RC2

This is a case-study type paper, examining what would happen to flood risk if particular types of historical storms occurred coincidentally with higher tide levels, on the German Bight coastline. It's not particularly novel scientifically, but these studies can be useful as evidence building for local impacts work so I would recommend publishing after some minor revisions. It summarises model runs of storm surges forced by a variety of met reanalyses. It appears to be sound in terms of method and results but doesn't communicate specific messages very well.

Wind speed and water level Feb 1962 and Jan 1976

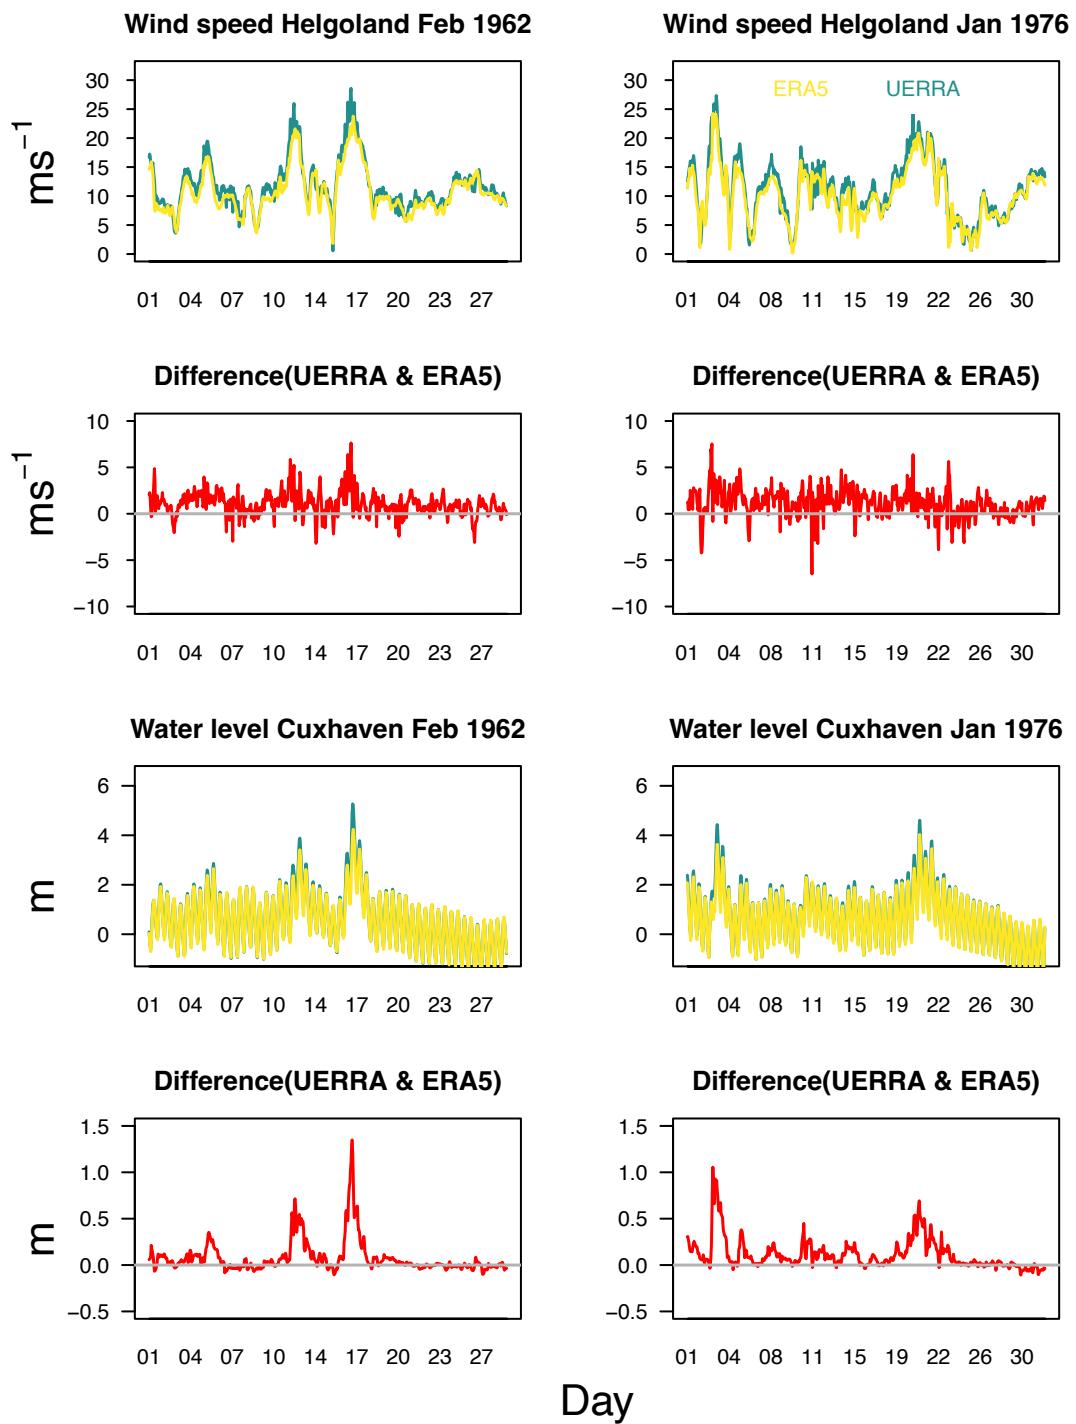
I find the consistent lower response of ERA5 quite surprising, and I'd like to know more about why this is seen, to know more about whether we should be using it elsewhere. In Fig 5, ERA5 appears to be lower than the other models outside of the storm window. What is the alignment like when there is no storm? Does it vary seasonally? It would be good to check in case there is just a constant bias that could be corrected easily.

We have not found a systematic bias in the 10m-height wind speeds, the major differences seem indeed to be limited to extreme wind events. Here we include two examples of wind speed and water level comparison of ERA5 and UERRA for Feb. 1962 and Jan. 1976 storms with an extended period, so that the calm conditions are also visible. The peak differences in wind speed and especially in water level coincide with the storm peak, whereas for moderate and calm conditions the differences are relatively small.

On a large scale, Campos et al. (2022) compared surface winds from ERA5 with satellite data globally. They found a very good agreement of the surface winds, especially for non-extreme conditions. They also pointed out that very strong winds in the North Atlantic were underestimated by ERA5 and the higher the percentiles, the larger was the discrepancy. Unfortunately, major part of the North Sea was omitted from their analysis due to too shallow water and related difficulties with the satellite data. However, these findings are in line with our results.

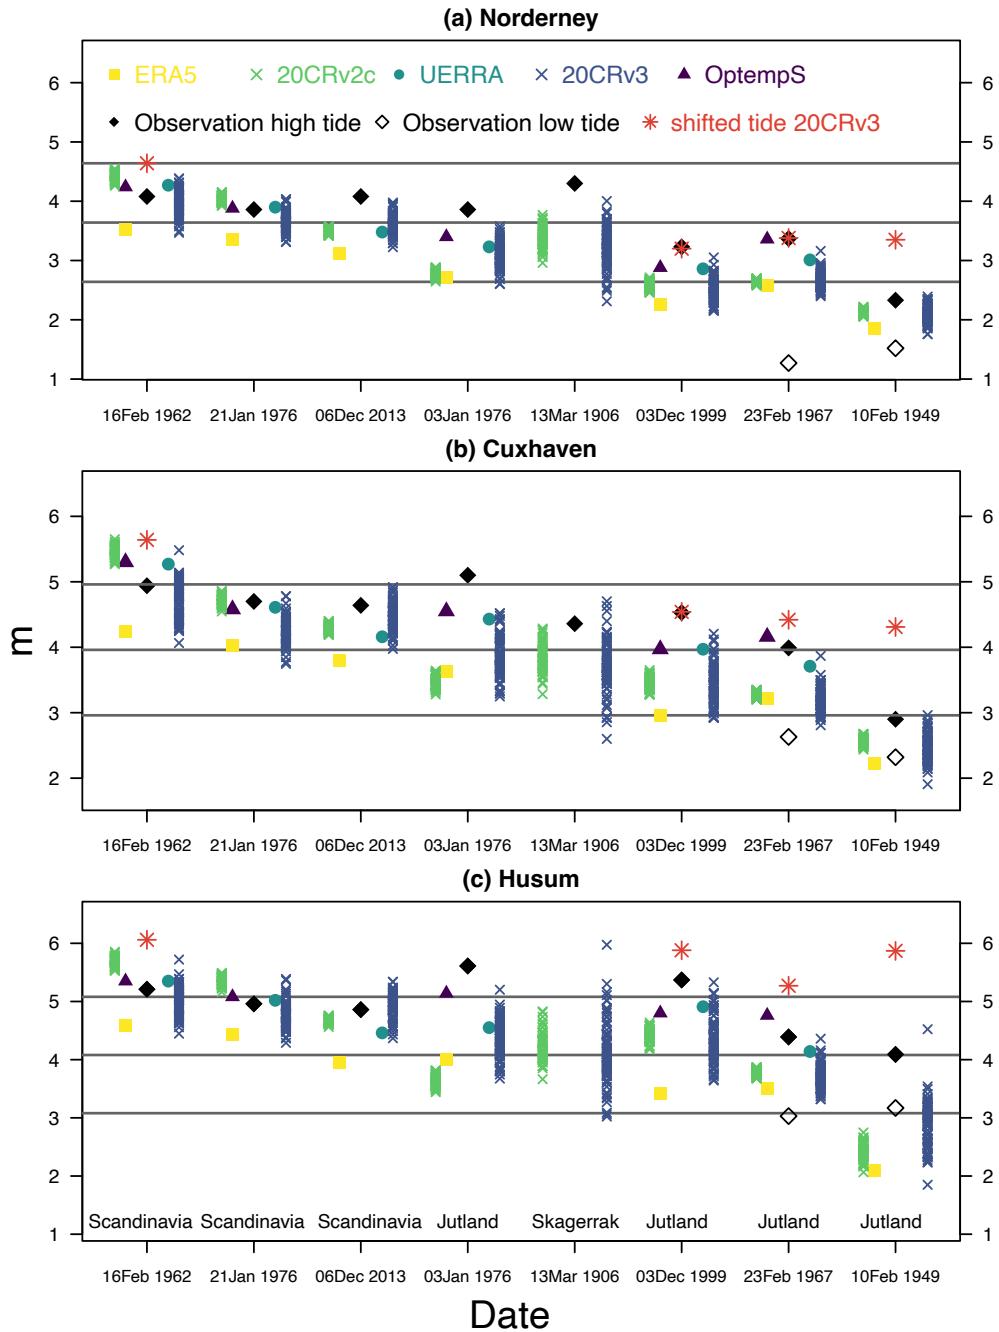
Then also sort by these clusters in other figs (eg Fig 6) so we can compare them more easily.

We have changed the Figure 6 according to your recommendation, see next page
